**RE: Value Planning Study Final Report – Comox Valley Water Treatment Project**

# Value Propositions Implementation Response

# Value Planning Study

Alternative No.: SC-23

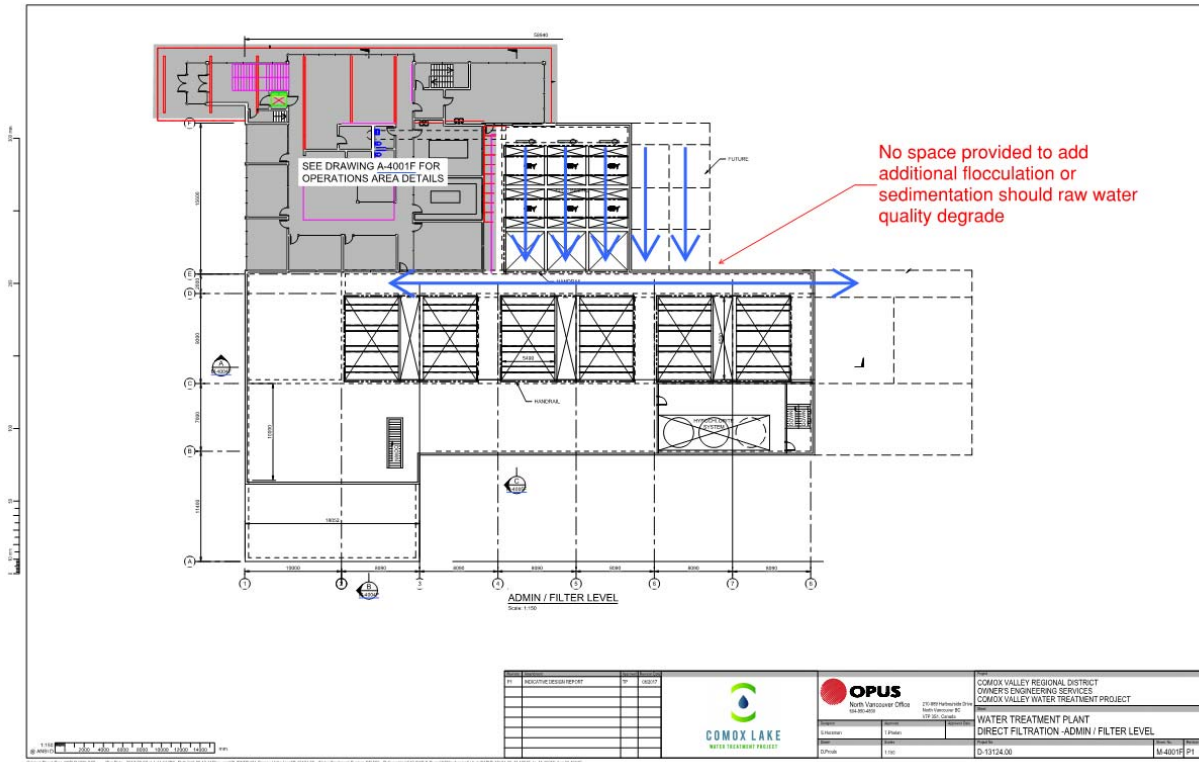
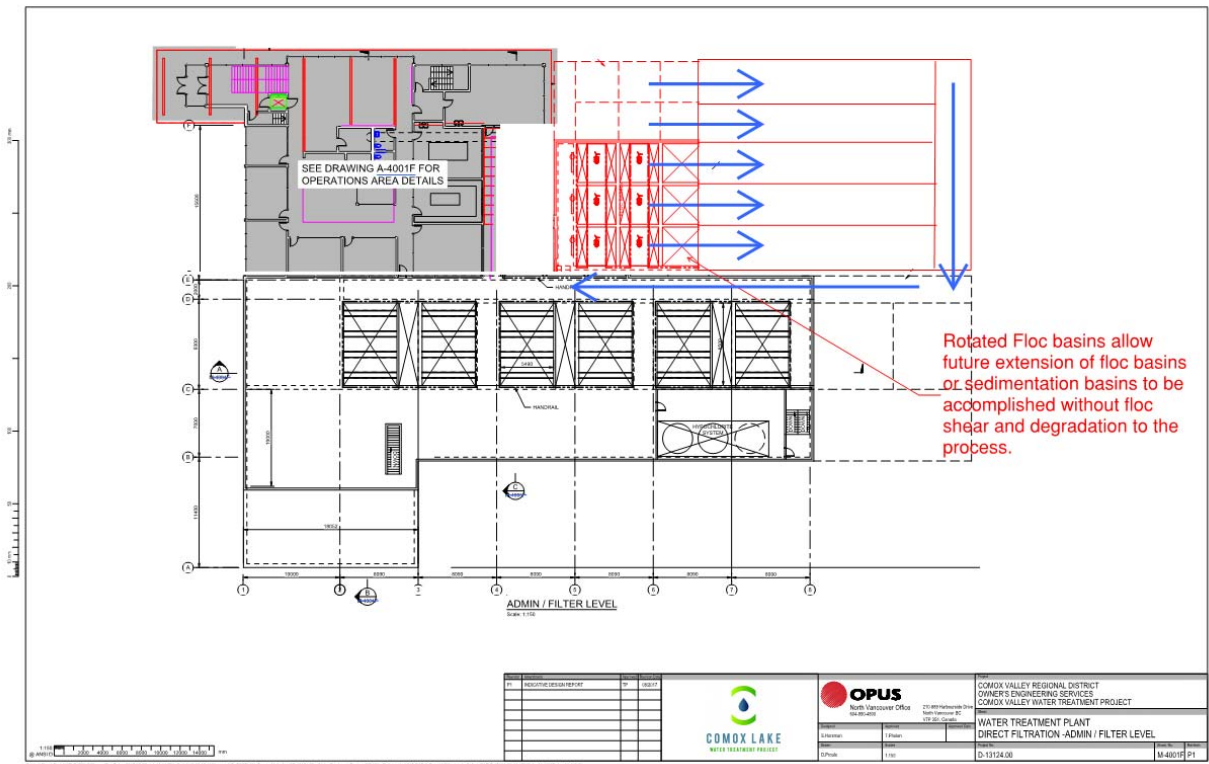
Original layout showing that extension of the flocculation basins or direct connection of sedimentation basins is not possible

Because only the realignment of the flocculation basins was accepted, this alternative will not provide any substantial cost savings. However, it may potentially provide cost savings if upgrades are required in the future.

Alternative No.: SC-28

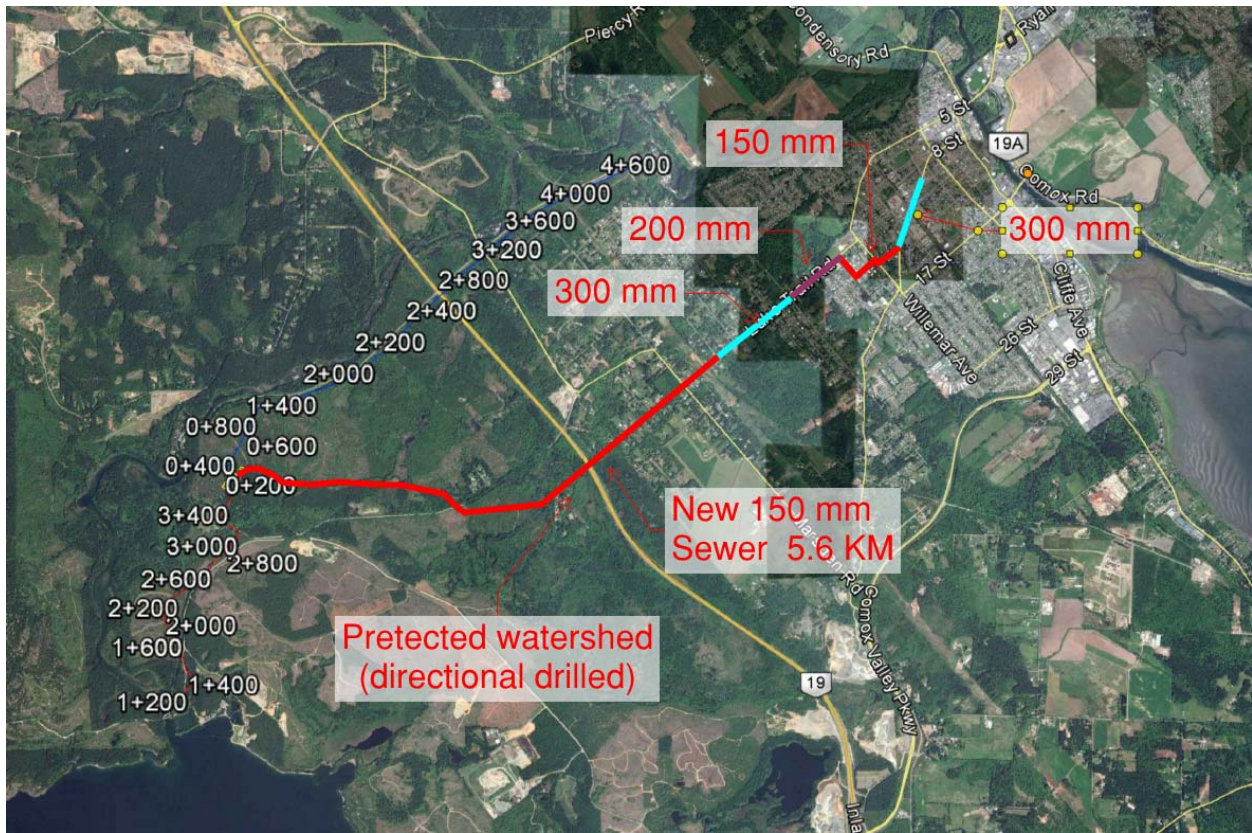
This is primarily a regulatory/permitting concern that may require undefined special design consideration that should be addressed at this time. The simpler course of action is to construct a sewer correction.

Alternative No.: G-05

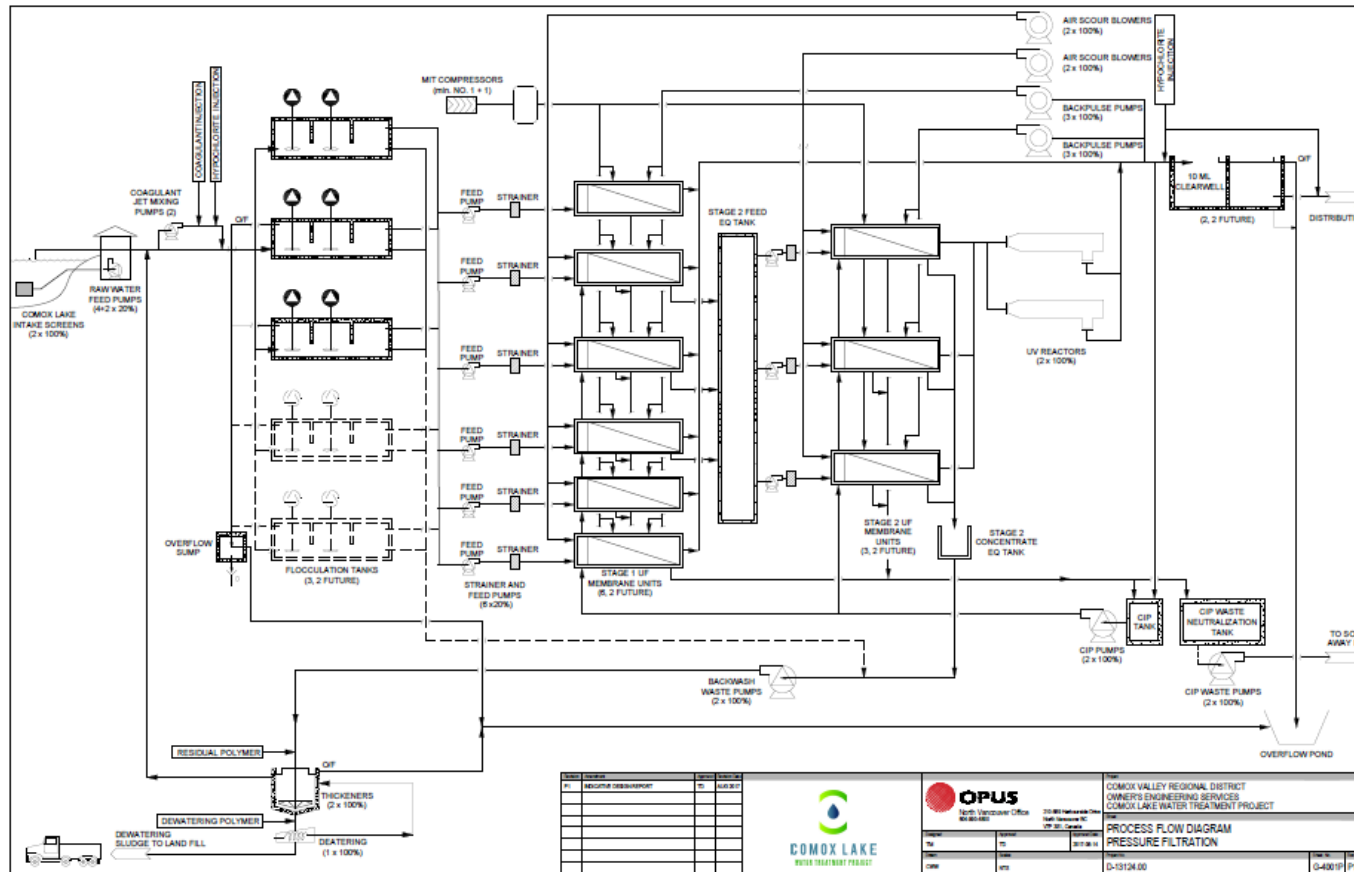
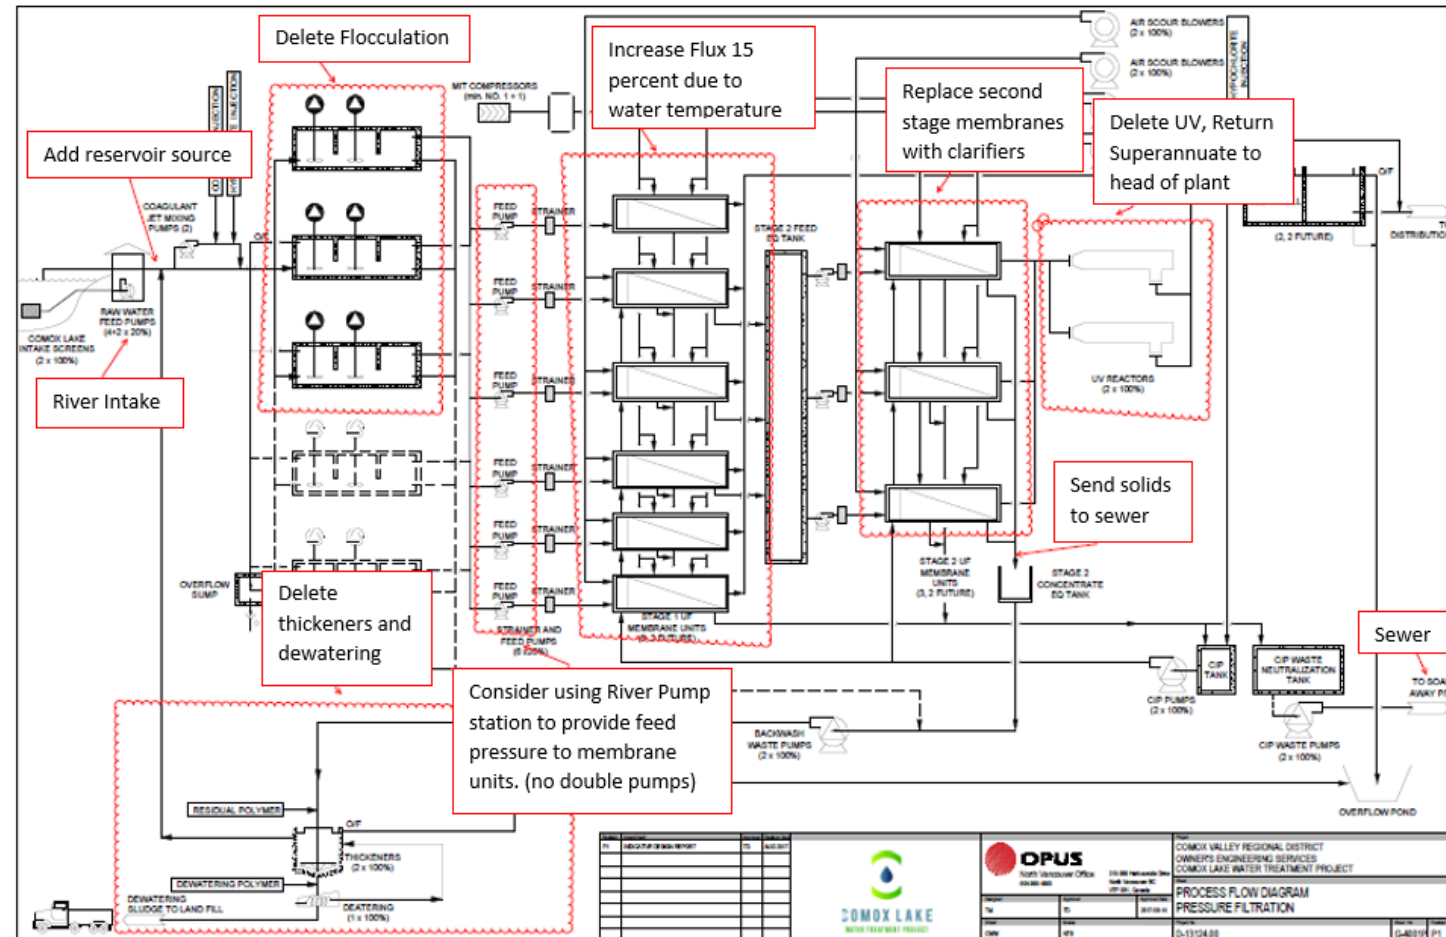
- Using solids from the plate settler at 1.0 percent solids sufficiently reduces the amount that can be discharged to a sewer. This eliminates the thickener and dewatering components of the design.

- Although not included as a component of this discussion, it may be possible to discharge the backwash water from the first stage membrane system to the Puntledge River, as only naturally occurring solids and no chemicals are contained in the backwash water. (MFLNRO)
